Proposed Renovations @
45 Montreal St., Portland, ME
October 30, 2014

1 Proposed First Floor & Site Plan (revised @ exterior only)
1/8" = 1'-0"

PROPOSED/REVISED
1st FLOOR PLAN
A4

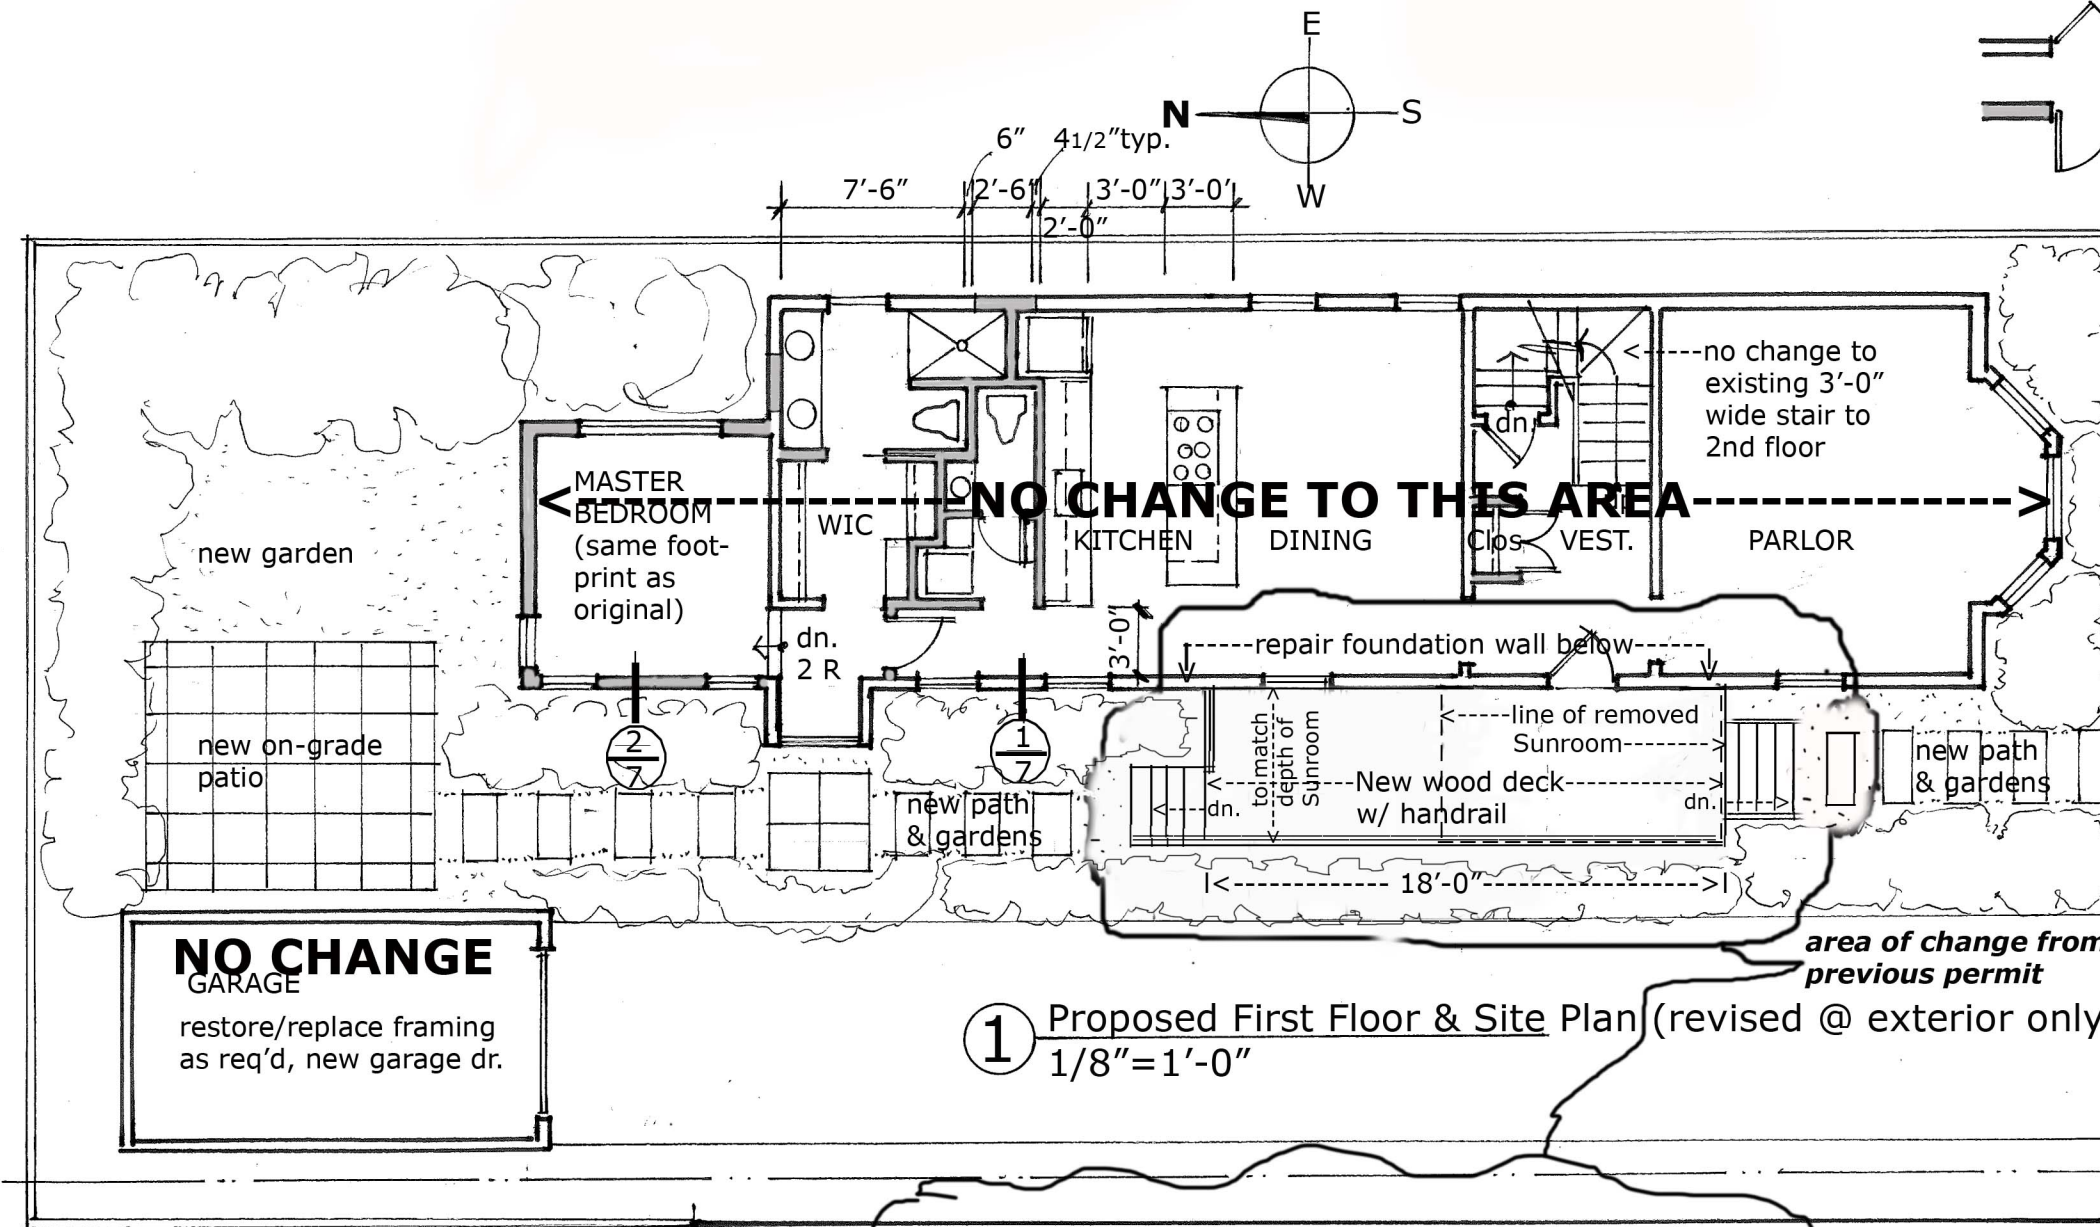
NOTE: this plan is submitted as an amendment to a previous application, approved and permitted, permit #2014-02228 dated 09/29/14. This drawing is submitted because renovation proceedings have uncovered foundation conditions which need to be addressed - specifically the foundation wall on the west side of the building, which needs to be shored, and which requires the existing Sunroom to be removed in order to properly stabilize the foundation wall. There is no change to the scope of renovations in the house or garage. The only change, as indicated in this drawing and application, is to repair the west foundation wall, to remove the Sunroom and to replace Sunroom with an outside deck.

1. Provide new concrete piers below deck framing - min. every 4' o.c..
2. All framing to be PT, min. 2x8's @ 16" o.c.
3. Provide guardrail @ 36" above finish floor of deck, with max. 4' between vertical posts and min. 4" spacing between horizontal rails.
4. Stairs on both sides of deck to be min. 3' wide and to have handrails @ 34" above nosing.
